53 Hume Street,
Crows Nest,
Sydney,
NSW

Application SSD-614000212 RFI Landscape Response

This formal response pertains to application SSD-614000212, Crows Nest Over Station development Site B and has been requested by the Department of Planning, Housing and Infrastructure (DPHI) as required under section 59(2) of the *Environmental Planning and Assessment Regulation 2021* to answer issues relating to the landscape architectural scope items raised in the relevant submissions. These issues are also outlined in Attachment A of the formal request for response letter sent by DPHI on the 19th September, 2025. RPS' comments are outlined below in Green and directly reference response letter produced by the Structural Engineer (Robert Bird Group):

Figure 1-1 Podium Facade Planting Outcome

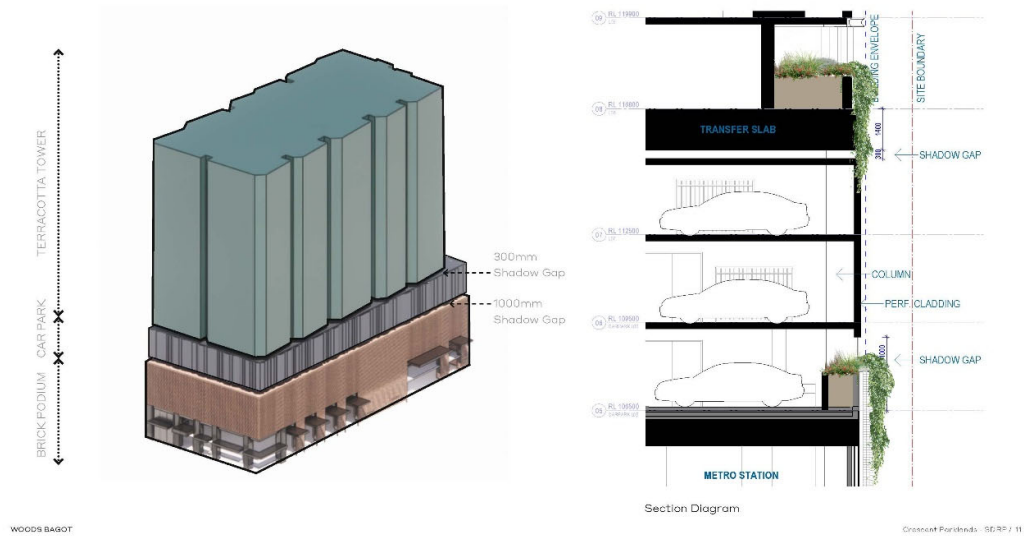
- a. Review and revise the façade treatments of the car parking levels to provide an appropriate horizontal height datum/ delineation between the station and the development (as recommended by the Design Guidelines) and to reduce its visual impacts. This may include consideration of:
 - i. Additional landscaping along the car parking level and provide details to demonstrate any landscaping would be practical and viable

Landscaping has been thoroughly interrogated across the extent of the podium through several building design iterations to ensure maximum possible landscape amenity is provided at the largest appropriate size; however as noted by the structural engineer in their response report, the ability for the built form to accommodate landscaping around the podium skirt is restricted by structural column and slab requirements.

With reference to the structural engineer's response report, landscaping can be maintained along three of the four facades with only planting to the Hume Street façade being omitted due to the introduction of a structural transfer slab removing planting opportunities.

Façade planting to the balance of the podium skirt will have more than ample soil depth at approx. 1500mm deep with a 1000mm air gap above the soil FFL to allow for medium to large cascading stock to be installed; This allows for the maximum immediate vegetation screening possible. Refer Figure 1-1 for a section view of a typical façade planter.
